PROJECT: Summerlin V25-Redpoint Drive

CITY OF LAS VEGAS		DATE:
INTER-OFFICE MEMORANDUM		April 27, 2019
TO: Land Development Services Department of Building & Safety		FROM: Albert Sung, P.E. Flood Control Project Engineer Department of Public Works
SUBJECT:	COPIES TO:	
Drainage Study for:	GCW Engineers / Surveyors	
Summerlin V25 – Redpoint Drive (Sky Vista to Fox Hill)		
Cross Streets:	Redpoint between Sky Vista and Fox Hill	Howard Hughes
File Number:	F:\Depot\DSMemos\DS5123A.doc	Bart Anderson, P.E., DevCo
Parcel Number:	137-22-101-001	
Zoning Action:		
FEMA Flood Zone	YES	NO X
Proposed Storm Drain	YES X	NO

The Drainage Study for the subject project has been reviewed and:

**TECHNICAL DRAINAGE STUDY
FOR
SUMMERLIN VILLAGE 25 REDPOINT DRIVE
SKY VISTA DRIVE TO FOX HILL DRIVE**

DRAWING PP4	THE HOWARD HUGHES COMPANY, LLC
	VILLAGE 25 REDPOINT DRIVE IMPROVEMENTS (SKY VISTA DRIVE TO FOX HILL DRIVE)
	PLAN AND PROFILE 4

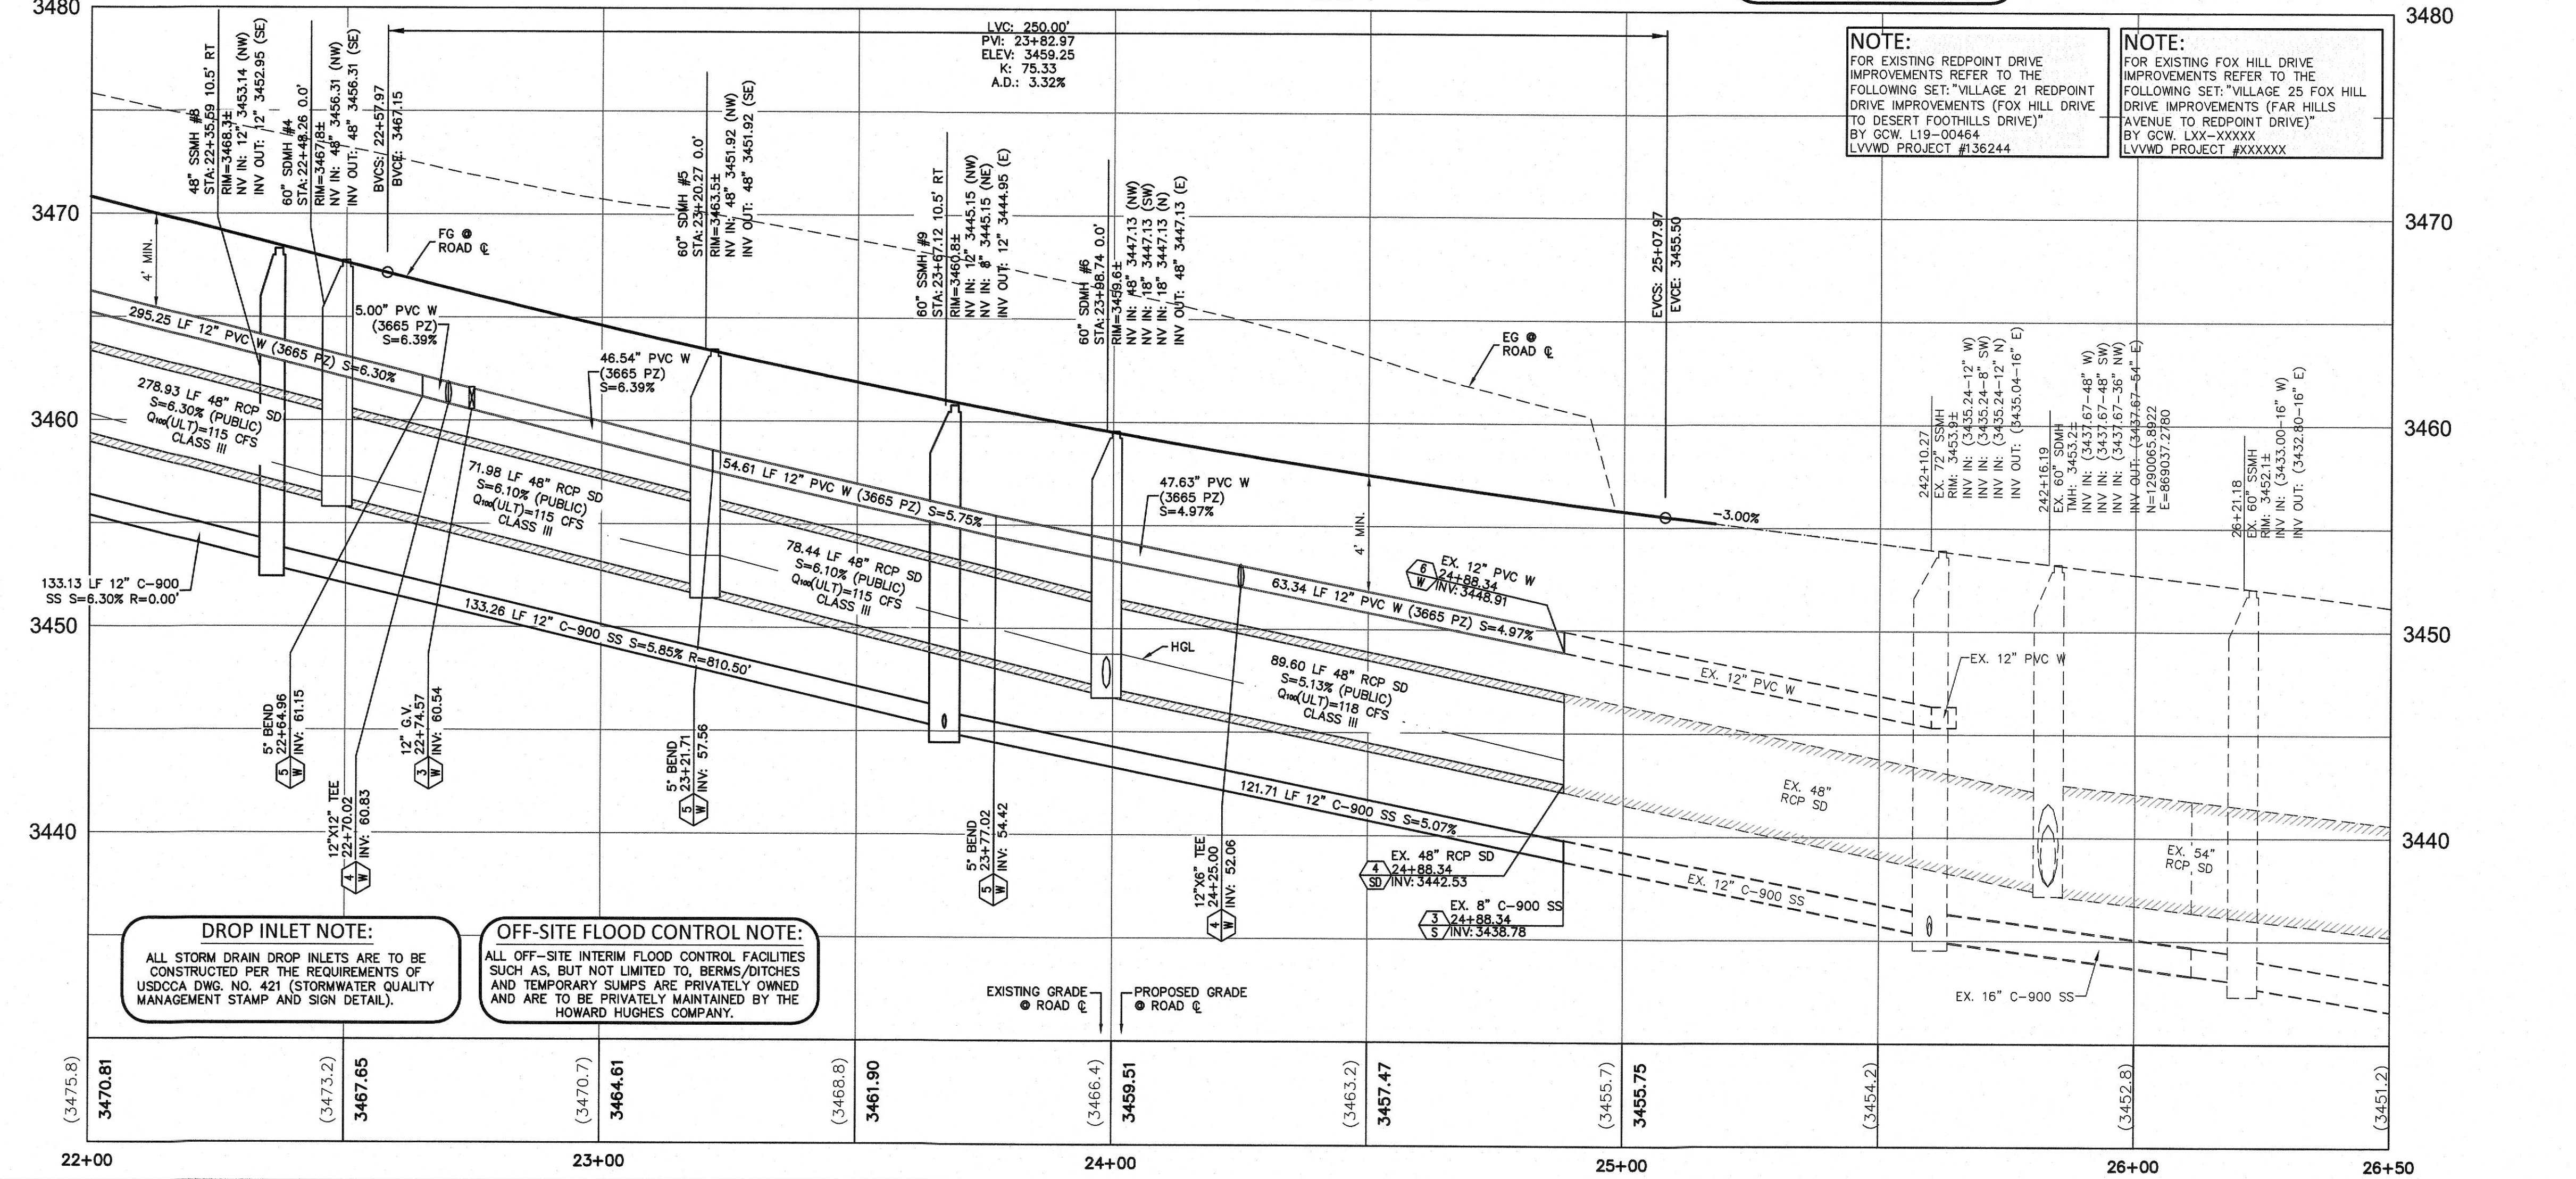
7. **Sheet PP4:** The proposed 48"-RCP ties to an existing 48"-RCP at Station 24+88.34 in *Redpoint Drive*. Provide connection detail in the next submittal.
